## MEMORANDUM

**TO:** Knoxville-Knox County Planning Commission  
**FROM:** Lindsay Crockett, AICP, Principal Planner/Design Review Program Manager  
**DATE:** July 31, 2024  
**SUBJECT:** Consideration of an appeal of the Design Review Board approval of 4-D-24-DT  
**FILE #:** 8-A-24-OB; Agenda Item #5

**0 W. Hill Ave. / Parcel ID 94 M D 018**

New primary structure (4-D-24-DT)

#### **3. GARAGE SCREENING**

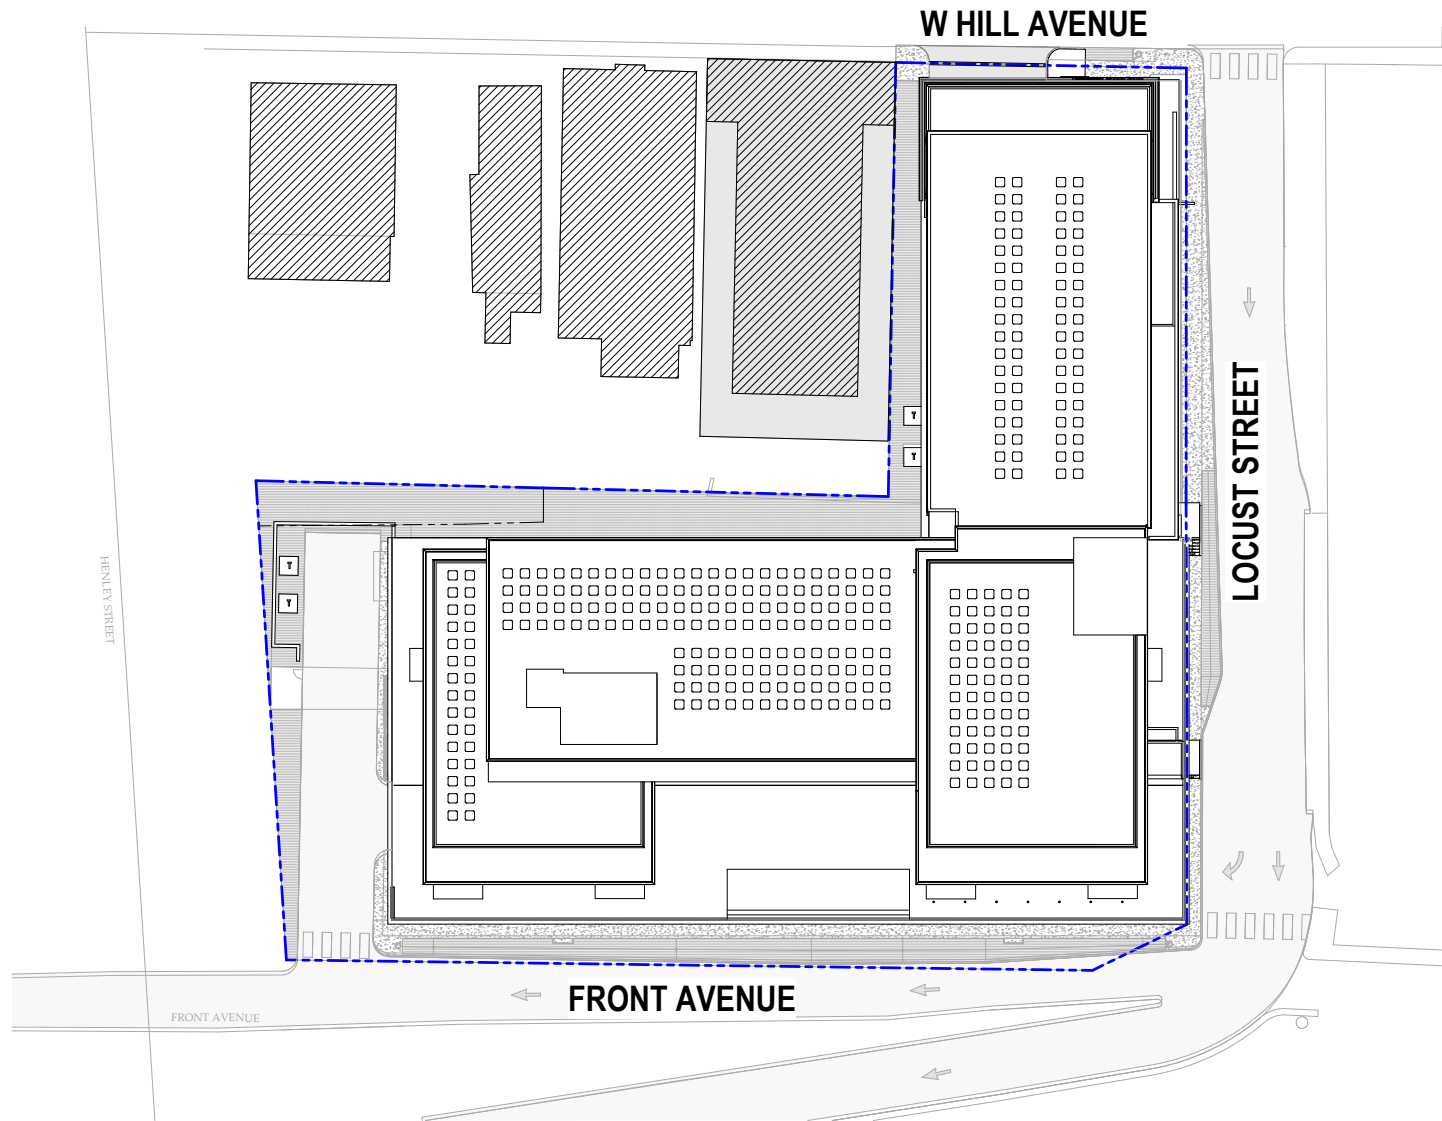
Viewing the massings horizontally, the south elevation was previously divided into two large sections of the parking garage and the residential massing. The parking garage has received substantial revisions since the initial application; revisions submitted for June incorporate vertical metal fins as screening for the parking garage. The vertical fins obscure the parking garage and are divided into two two-story sections, which further reduces the visual scale of the garage.

At previous meetings, the Board has extensively discussed the scale of the building's south massing in relation to the context of the area. The Boulevard District guidelines recommend "building forms that are complimentary to the mass of adjacent buildings." The building section along Hill Avenue is generally compatible in scale with the adjacent building, measuring one story taller. The buildings along Hill Avenue steps from six stories, to three stories, to two stories, to 1.5 stories. The broader context is varied in scale, including taller historic structures, surface parking lots, the Bank of America building, and the City-County Building. In the opinion of staff, the revised proposal is compatible with the context.

The parking garage has been screened with vertical metal fins, angled to visually obstruct the garage structure while maintaining the required amount of openness to achieve natural ventilation of the parking garage. The metal fins are two stories in height, giving the appearance of two stories of parking rather than four, while maintaining a scale complementary to the Henley Street Bridge. The composition of concrete columns at street-level with vertical fins above is subtly referential to the massive concrete bridge piers touching down along the river with the repetitive rhythm of its pedestrian level guardrail above. The result is a thoughtful, timeless design approach to the garage treatment that complements the architectural language of the building above.

LOADING - OVERALL FLOOR PLAN

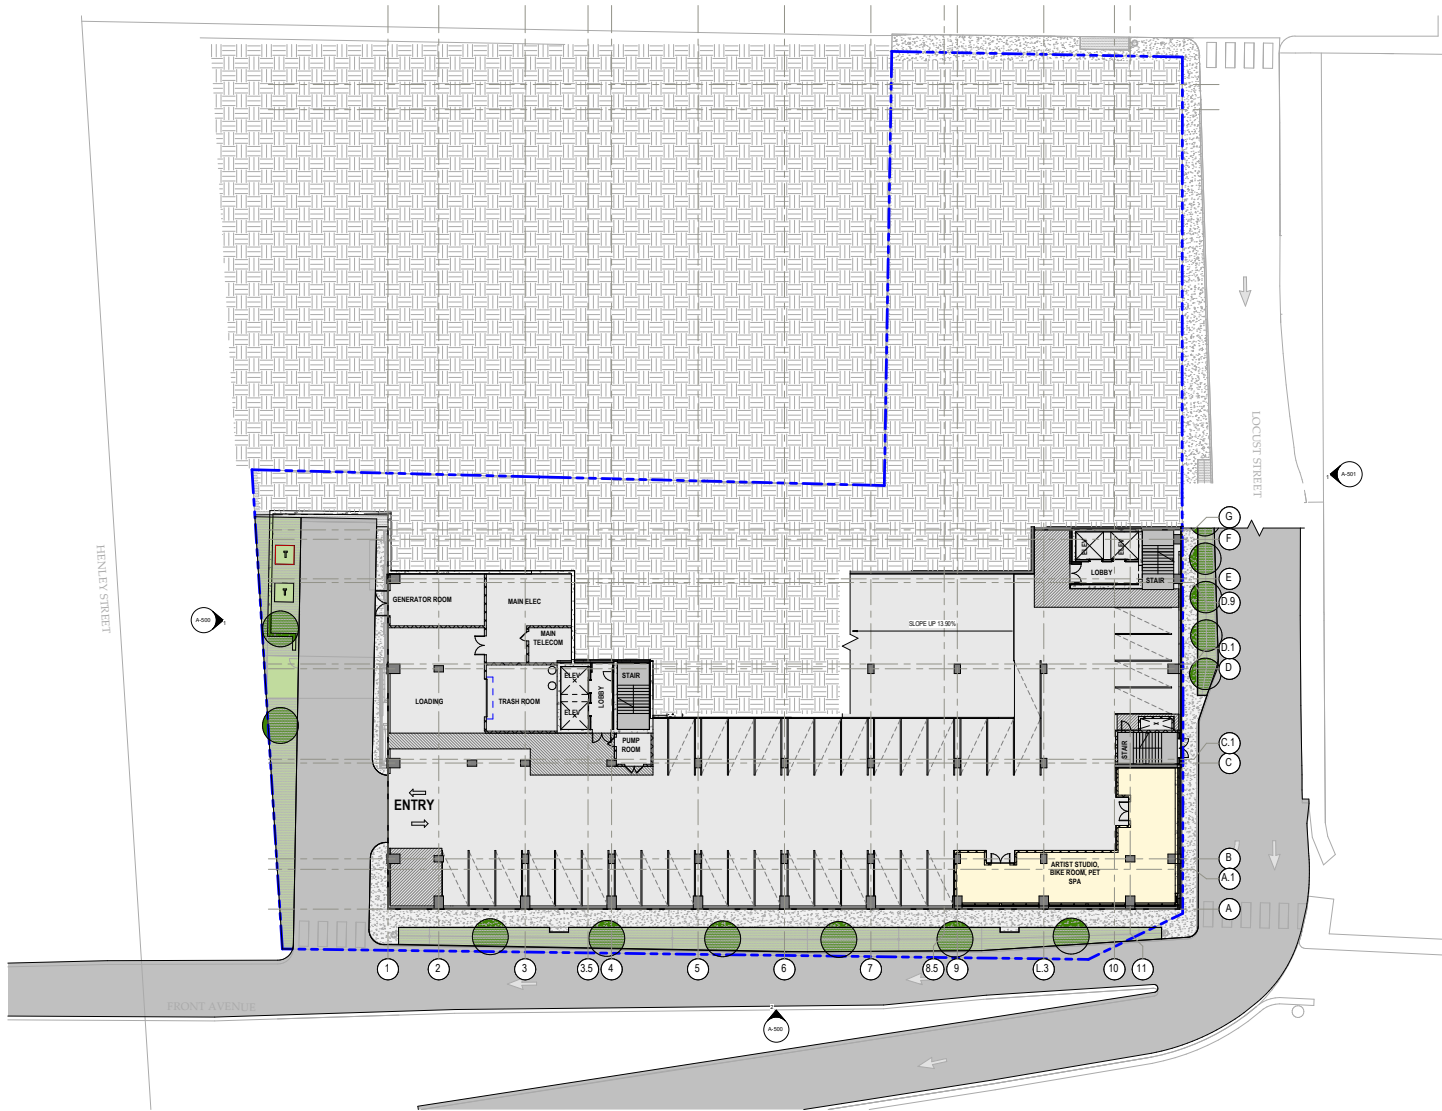
- 2. PARKING: the application includes a 5-story structured parking garage, with access off Front Avenue and W. Hill Avenue. The primary garage access point is located on W. Hill Avenue, and will feature two separated lanes for vehicle ingress and egress. The revised application includes a secondary access point off Front Ave. The parking garage generate an increase in vehicle traffic for W. Hill Avenue and Front Ave. Guidelines recommend "consolidating curb-cuts and locating driveways near mid-block, when necessary," and prioritizing pedestrian safety. The access point on Hill Ave does meet the guidelines (consolidating the driveways into one curb cut) but additional

information may be necessary for permitting related to mitigation of any potential sight distance issues for cars exiting the garage, pedestrian safety measures on the sidewalk on Hill Avenue, and any necessary safety measures for cars using Front Ave to access Locust or Neyland Drive. The final site plan and garage should meet City Engineering standards.
